PROPONENT'S RESPONSE TO SUBMISSIONS

Public Environmental Review
Coburn Mineral Sand Project

Gunson Resources Ltd

4 October 2005

Graph 1: Distance drawdown plot showing the parameters required to achieve the measured drawdown in DMB1.

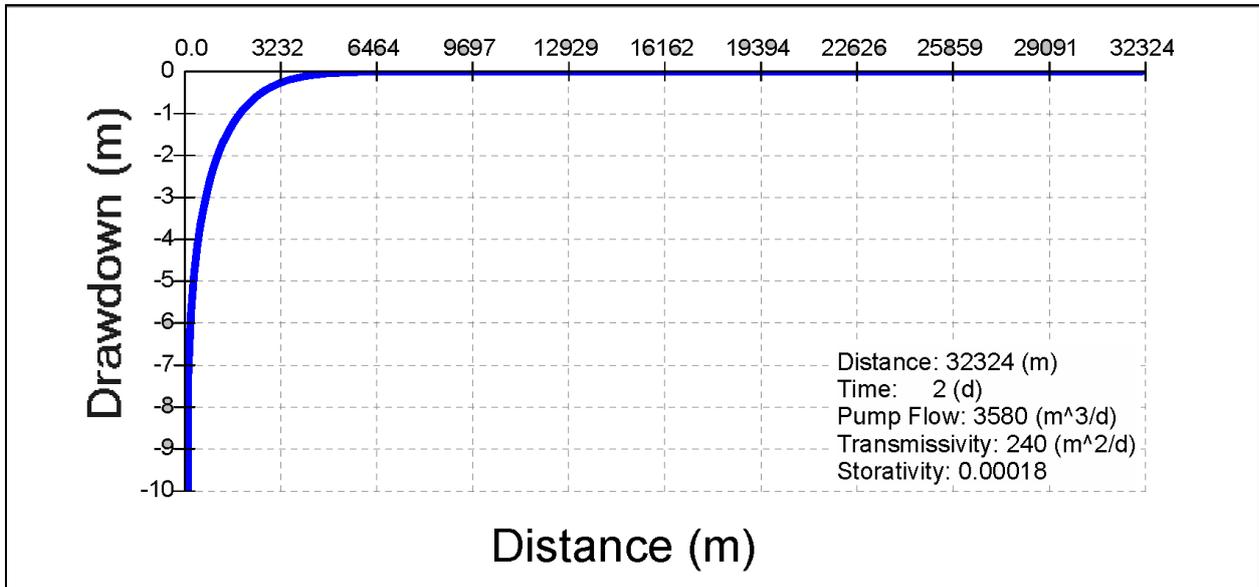
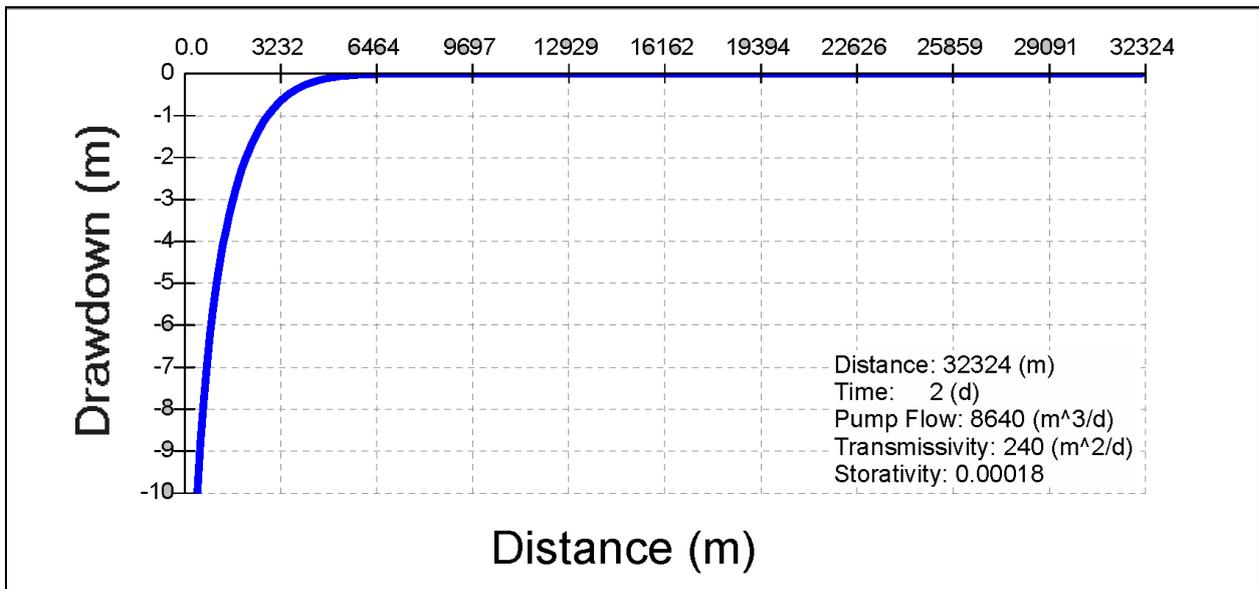
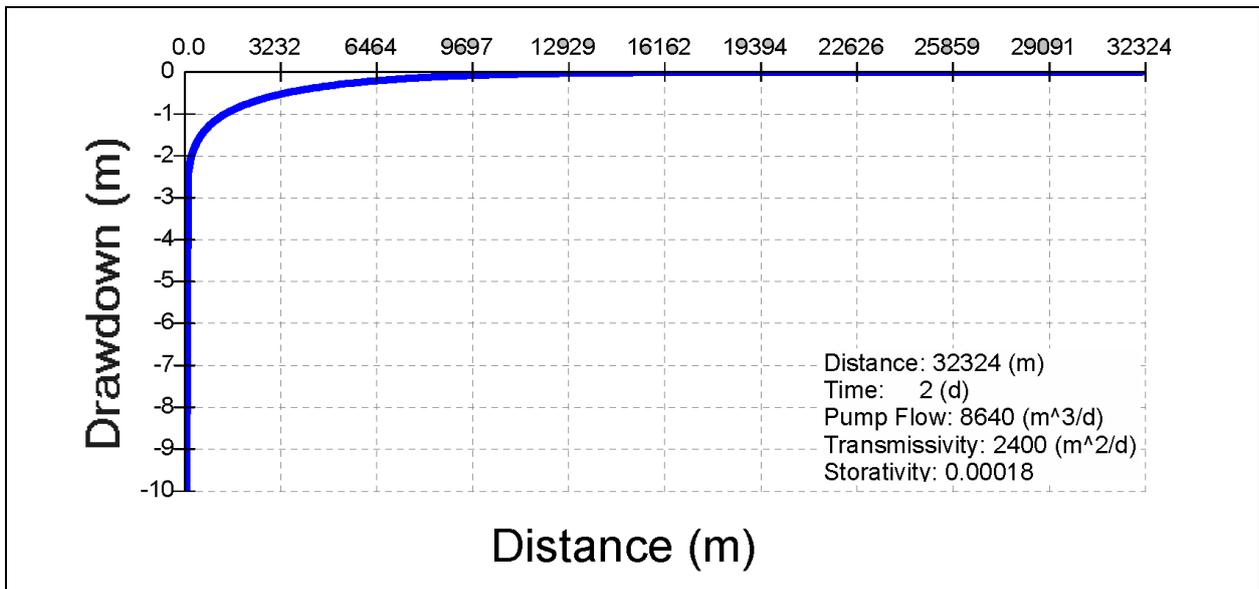
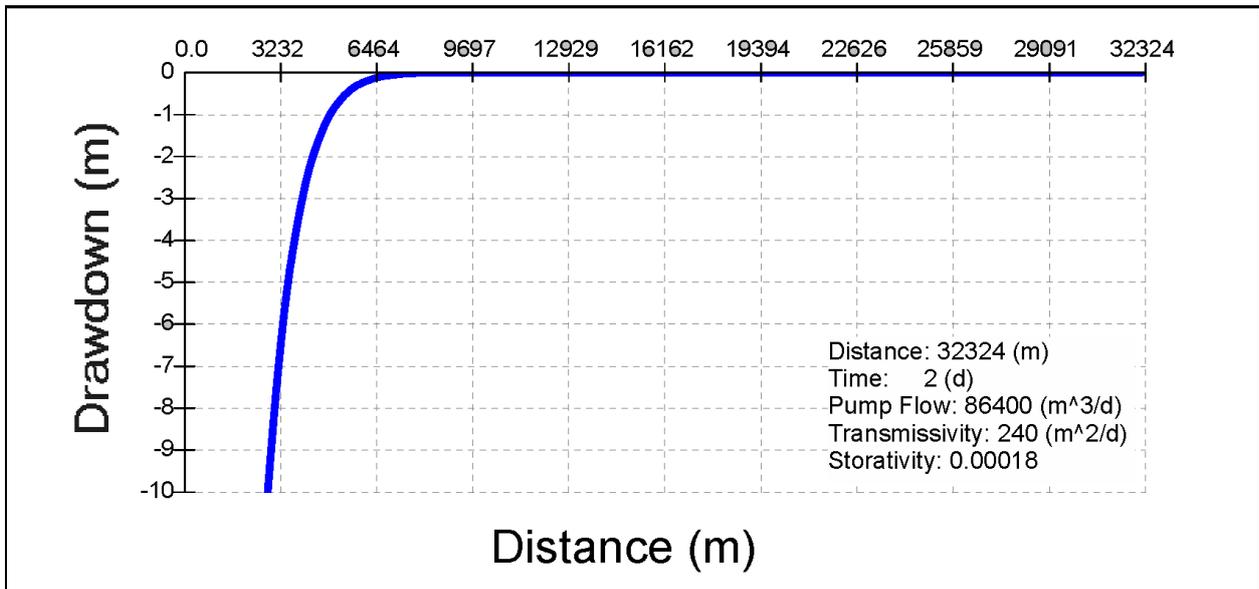
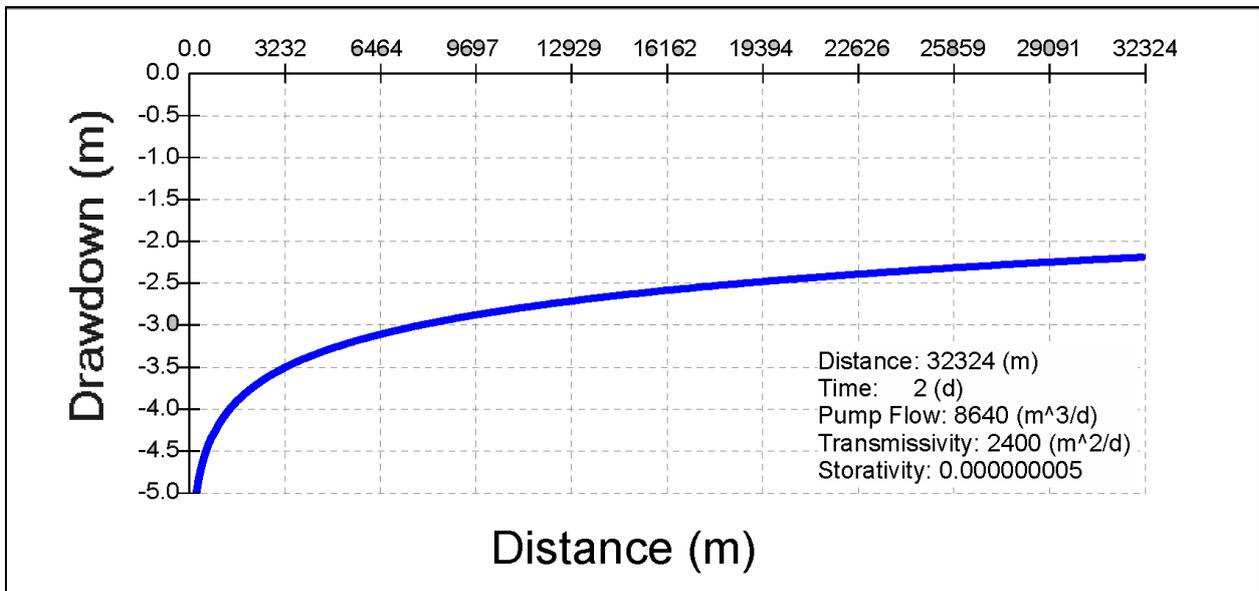
It was indicated in Submission 6 that an immediate 2.1 to 2.8 m (3 to 4 psi) drawdown effect in Hamelin Homestead No.1 during the two-day aquifer test in DTB1. Our interpretations of the aquifer test data show that this outcome is highly improbable. The measured drawdown response in the Birdrong Sandstone in DMB1, 1 km from DTB1, was 2.2 m. The 2.1 to 2.8 m (3 to 4 psi) pressure drop in Hamelin Homestead No. 1 quoted in Submission 6 is not compatible with the measured aquifer test results, given its distance of about 32.3 km from DTB1. Using the hydraulic parameters derived from the aquifer test, it is likely the drawdown effects after two days of pumping may have extended to about 3.5 to 4 km from DTB1. Even if all abstraction is from the Birdrong Sandstone, measurable drawdowns would only have extended about 5 km from DTB1. It would require the application of unrealistic aquifer parameters to propagate drawdown of 2.1 to 2.8 m (3 to 4 psi) to Hamelin Homestead No. 1 during the aquifer test in DTB1. Such parameters might include an aquifer transmissivity ten times higher than that interpreted or recognised for the Birdrong Sandstone, and a storage coefficient some six orders of magnitude lower than interpreted at DMB1. The above statements are demonstrated by Graphs 1 to 6.

Graph 2: Distance drawdown plot between DTB1 and Hamelin Homestead No.1 using interpreted aquifer parameters.

Graph 3: Distance drawdown plot between DTB1 and Hamelin Homestead No. 1 with all abstraction assigned to the Birdrong Sandstone.

Graph 4: Distance drawdown plot between DTB1 and Hamelin Homestead No. 1 with a 10-fold increase in the Birdrong Sandstone transmissivity and all abstraction assigned to the Birdrong Sandstone.

Graph 5: Distance drawdown plot between DTB1 and Hamelin Homestead No. 1 with a 10-fold increase in the abstraction assigned to the Birdrong Sandstone.

Graph 6: Distance drawdown plot between DTB1 and Hamelin Homestead No. 1 with a 10-fold increase in the transmissivity of the Birdrong Sandstone, together with a storage coefficient six orders lower than interpreted and assuming all abstraction was from the Birdrong Formation. All of these conditions are unrealistic in the context of the known regional hydrogeology.
